RE: Bid Addendum #3
County Road 127 North – Phase 2
Baker County Project No. 2021-21

Following are questions (Q#) in **bold** text followed by responses (R#) in normal text.

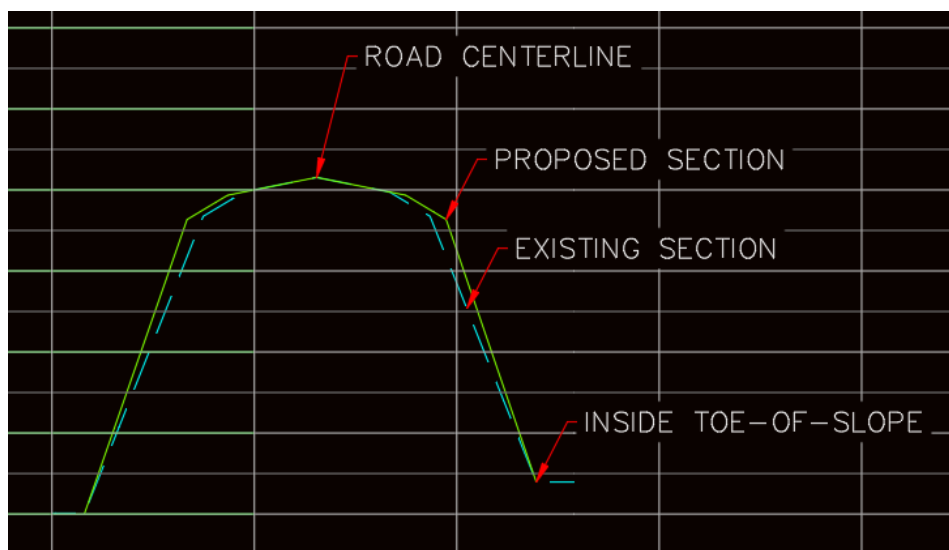
Q3 If there is no topo available, what information was used to quantify the excavation required to create the 2-3' flat ditch bottom on each side of the road (as shown in typical section) for the length of the project? To clarify, the excavation quantity area in question is from the ditch out to the ROW.

R3 The existing and proposed conditions surfaces used to calculate the earthwork were generated as follows:

1. Roadway centerline alignments and vertical profiles were defined from original FDOT design plans with horizontal and vertical adjustments made to best fit aerial imagery and survey data collected at the cross drains.

2. An existing conditions corridor model was then generated using the adjusted horizontal alignments and centerline profiles and the existing roadway typical sections (road segments 1 and 2 have different existing conditions typical sections). This model accounted for superelevation using standard methods.

3. A proposed conditions corridor model was then generated using the adjusted horizontal alignments and centerline profiles and the proposed roadway typical sections (road segments 1 and 2 have different proposed conditions typical sections). This model also accounted for superelevation using standard methods.

4. A volume surface was then generated that compared the proposed surface and the existing surface. The two surfaces tied into each other at the location of the inside toe-of-slope. Below is a section view of the two surfaces at an arbitrary point along the roadway.

5. Earthwork for excavation associated with road widening and for fill at individual cross drain extension locations were also factored into the overall earthwork quantities specified in the bid form.

The existing and proposed corridor models were generated making a number of assumptions and using the best available data. For example, toe-of-slope locations were determined using aerial imagery and using field measurements of side drain offsets along the roadway.

Earthwork calculations do not include any work beyond the inside toe of slope of the roadway embankment. The contractor shall prepare their bid such that earthwork does not extend beyond the inside toe-of-slope except at cross drain locations as shown on the plans. Any work beyond the inside toe-of-slope, if required, shall be the responsibility of Baker County.
